**PLANNING DEPARTMENT  
CURRENT PLANNING DIVISION  
ADMINISTRATIVE SITE PLAN REVIEW**

**CASE NO:** 2016-0136

**REQUEST:** Administrative site plan review for a recycling transfer facility

**LOCATION:** 229 East Whitney Road, Anchorage, AK 99501

RECYCLING TRANSFER FACILITY  
SITE PLAN WITH TOPO (NO LABELS)

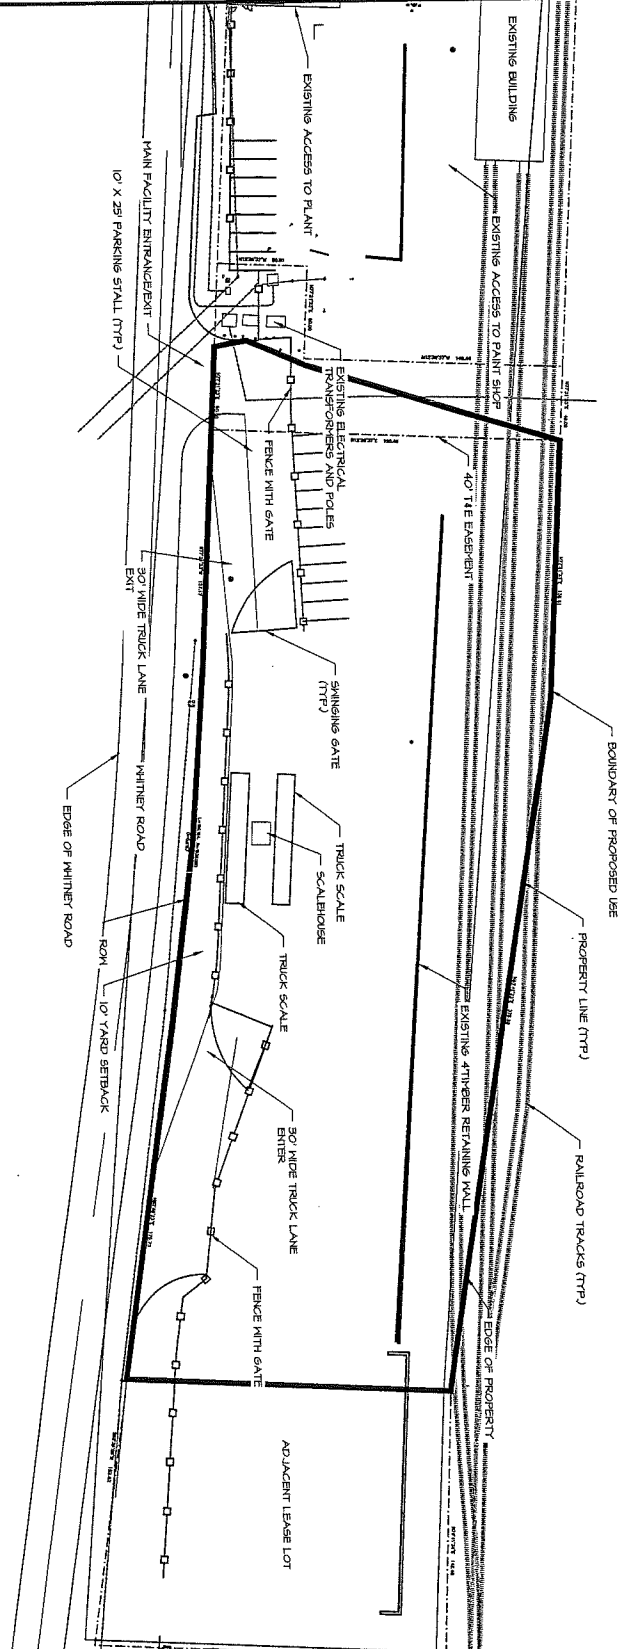
LOT 4 Ship Creek Crossing Subdivision is located at 229 E Whitney Road. This section of Whitney Road is a 60 foot ROW designated as a Collector in the OSH&P. The Site plan shown on figure 1 of the application appears to be a conceptual layout for a proposed recycle transfer facility.

Traffic Department recommends that the site plan be revised to address the following comments based on review of New Title 21 Land Use Code prior to recommend approval for this new use.

1. Provide a recorded copy of the snow removal agreement with Municipality (21.07.040 F)
2. Note 4 indicated that existing area is gravel and that existing drainage will not be impacted by development. A portion of the existing lot will require to be paved which will change the amount of impervious surface and potentially impact Drainage and Storm Water treatment for the site.

3. Provide a sidewalk along the portion of Lot 4 frontage to Whitney Road (21.07.060 E2.B). Information provided in application indicate that future modification of existing building on the lot may include future change of use that will require pedestrian accessibility to the site.

4. Table 21.07-4 does not list a specific requirement for the proposed use category and there is not a land use listed in the ITE parking generation manual. 21.07.090 E.2 requires a minimum of three (3) spaces. This portion of the site will need to provide sufficient number of parking spaces for the amount of employees required for operation of the recycling transfer facility. Figure 1 indicates a total of 10 spaces located adjacent to new fencing near main facility entrance area. Provide additional information with revise site plan indicating that 10 space would be sufficient to support center operations.

5. Provide additional information on revised site plan for proposed parking area to include more than typical dimensions. Indicate circulation to access the spaces. Provide notes for required pavement markings and potential for wheel stops (21.07.090 H.8)

6. Show information on revised site plan to address requirement for exterior lighting (21.07.090 H.5)
7. Show information on revised site plan to indicate areas to be paved to include the following, Driveway entry and exits, truck scale access, and parking spaces and circulation areas (21.07.090 H 12).

8. Revise site plan to show one van accessible parking space (21.07.090 J)
9. Revise site plan driveways to meet Municipal Driveway Standards for the following;
  - a. Provide driveway curb cut with sufficient radius to support large commercial vehicles (Paragraph 2b).
  - b. Indicate width of driveways meeting commercial standards (Paragraph 5a).
  - c. Revise driveway angles to Whitney Road Driveway angles should be 90 degrees and not less than 60 degrees (Paragraph 6a).
  - d. Provide a 30 foot +/- 2 % landing grades for driveways to Whitney road (Paragraph 8b)
  - e. Provide additional information with use of vehicle turning templates to demonstrate ability for large commercial truck to make a left turn from Whitney road to the eastern entrance driveway for the vehicular scales
10. Obtain a title 23 land use permit for required site modifications.

1. All construction and improvements related to this approval shall be substantially in compliance with the administrative site plan application, narrative, and plans submitted to the Planning Division, unless otherwise amended to satisfy the approval conditions.  
Recycling Transfer Facility; prepared by: LMR; Environmental Management Incorporated, Figure 1, dated 12/12/16

4. Resolve with the Traffic Engineering Department, the need to install sidewalks along Whitney Road in accordance with AMC 21.07.060E.2.b.
5. Resolve with the Traffic Engineering Department the parking lot layout, design, and illumination. If it is determined that more than ten or more parking spaces are needed, the petitioner shall establish parking lot perimeter landscaping in accordance with AMC 21.07.080E.2.b.
